## MR #2023016 – BOWIE MILL ROAD BIKEWAY

### Description

NO. MR2023016

Item No. 7

Figure 27: Area of Shared Maintenance under Memorandum of Understanding within Bowie Mill Local Park

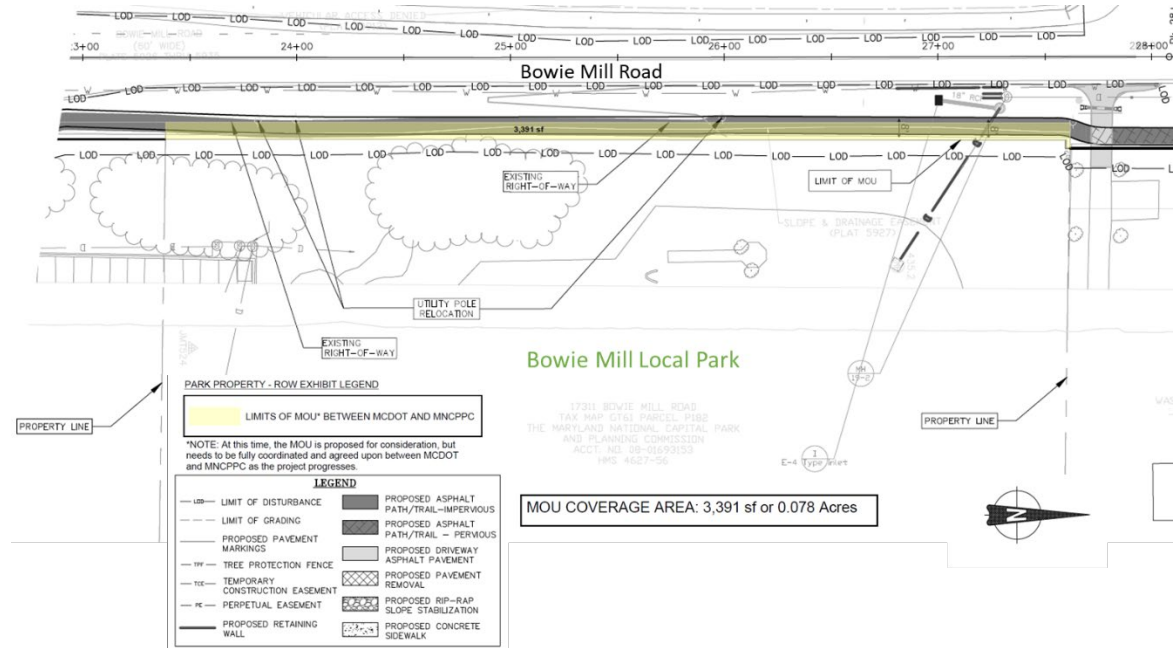
**Recommendation: MCDOT and Montgomery Parks will continue to coordinate on a Memorandum of Understanding (MOU) at Bowie Mill Local Park regarding access and maintenance of the portion of the sidepath and lighting on parkland, which must be agreed to and finalized before the issuance of a Park Construction Permit.**

Along the frontage of Bowie Mill Local Park, the sidepath and lighting will be located on park property. A Memorandum of Understanding (MOU) will be utilized at Bowie Mill Local Park and no perpetual easement will be granted (Figure 28). The MOU will establish the agreed upon maintenance responsibilities between MCDOT and Montgomery Parks in the shared maintenance area on parkland,

which will include approximately 3,390 square feet of parkland. MCDOT will be responsible for the maintenance of the sidepath and lighting.
